## ***Interactive comment on “Theory of the generalized chloride mass balance method for recharge estimation in groundwater basins characterised by point and diffuse recharge” by N. Somaratne and K. R. J. Smettem***

**Anonymous Referee #1**

Received and published: 8 February 2014

Figure 4.2. Calibration curve, constructed using mean predicted and mean observed groundwater levels (ULE099; ULE101; ULE102; ULE114; ULE134; ULE145). Inset: Scatter plot of mean observed and mean predicted groundwater level data. Individual calibration curves for each well are shown in Appendix C.

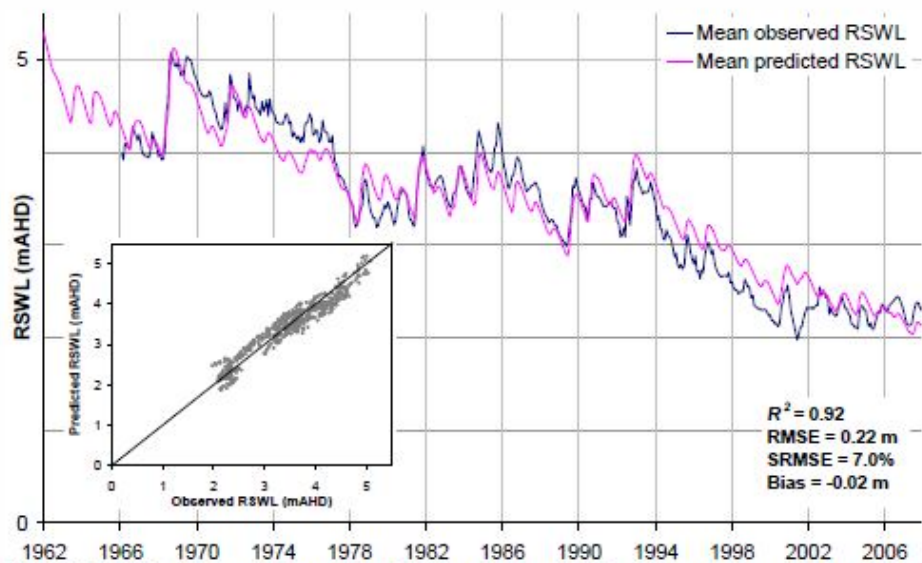
12. It is worth considering some additional evidence in regards to the basic claim by the authors that Uley South recharge ought to be doubled. Uley South has been pumped at rates between about 4 and 7 GL/yr in the recent decade or so. Across the area of the basin (113 km<sup>2</sup>), this is the same as 35 to 62 mm/year of outflow. Despite claims to the contrary, the groundwater storage has most certainly declined (from 1970s to early 2000's - see attached figure from an honours thesis by D. Alcoe showing the average watertable response from several observation wells), then stabilised, and then shown signs of recovery (after 2010), and these stages correspond to periods of higher pumping and then reduced pumping. At its lowest, the water levels in Uley South were marginally higher near the coast to density-corrected sea level, and hence if we consider that discharge to the sea at that time was perhaps small, it seems unreasonable to accept a recharge estimate of 120 mm/year (i.e. twice the high-pumping rate during a period of watertable decline) across the basin, in this semi-arid environment and considering the significant proportion of this uninhabited basin that is thick with vegetation cover. It simply doesn't add up. We can at least infer that recharge has exceeded the lower pumping rate of 35 mm/year, given evidence of watertable recovery.
